Dauphin County Subdivision/Land Development Review Report

Municipality	City of Harrisburg		Surveyor	Act One Associates		Engineer	Christian B. Cobaugh PE		
Plat Title	Capital Heights Redevelopment (Phase 3) Midtown Development LLC								
Zoning District	RM – Residential Medium Density District			Proposed Land Use	Single Family Multi Family & Commercial Mixed Use				
Plat Status:	Preliminary	Plat Type:	Subdivision	Regulations:	County				
	Final		Land Development		x	Municipal			
x	P/F	X	Combined		x	Zoning			
	Minor				x	S&LD			
# of Lots	37	# of New Lots	11	# of New D.U.s	64	Acreage Subdivided/Developed	1.85	Total Acreage	1.85
Date Received	6/24/2024		Staff Review	7/10/2024		Official County Review	7/10/2024		
Reviewed by	GD		Checked by	Parcel No. 12-11-037 (and 36 others)

Project Description: To redevelop long vacant lots to bring a mixture of housing and commercial usage.

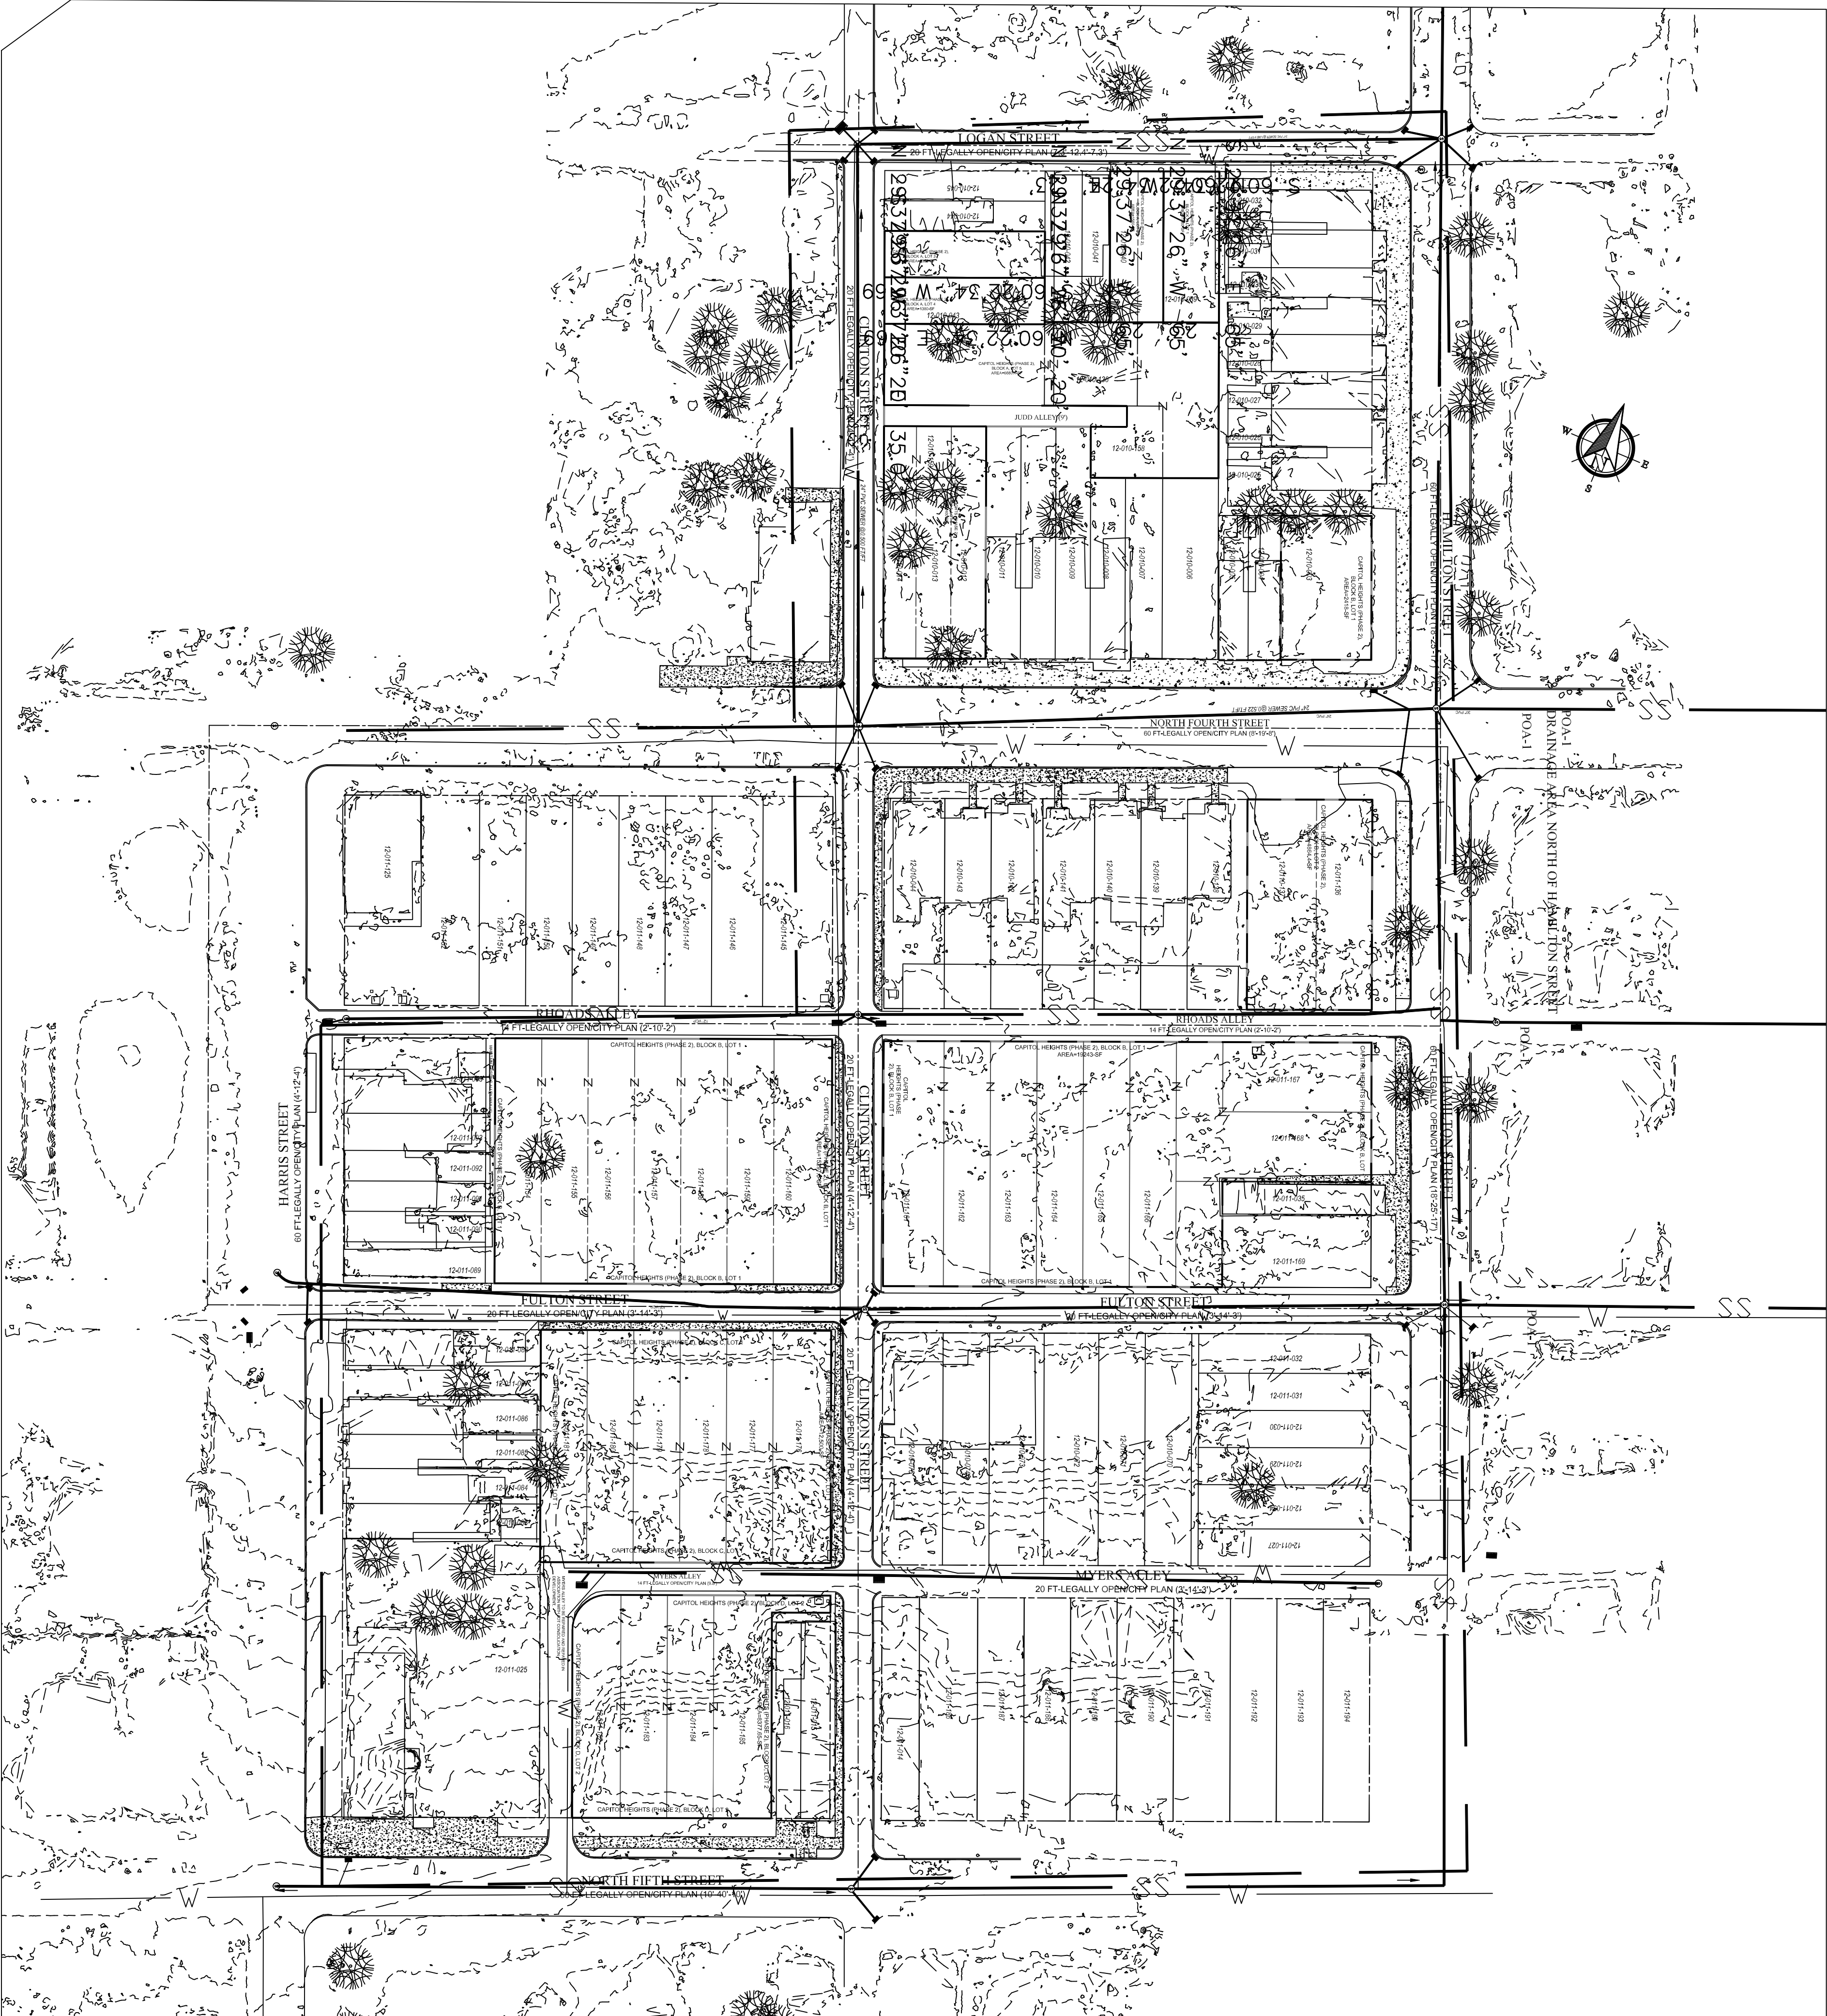
2. In addition to that listed above, the Dauphin County signature line should have line each for the Commission's Chairman and Secretary.
3. It appears the north arrow shown on the plan is in error.

GENERAL NOTES: PROVIDE GENERAL NOTES.....
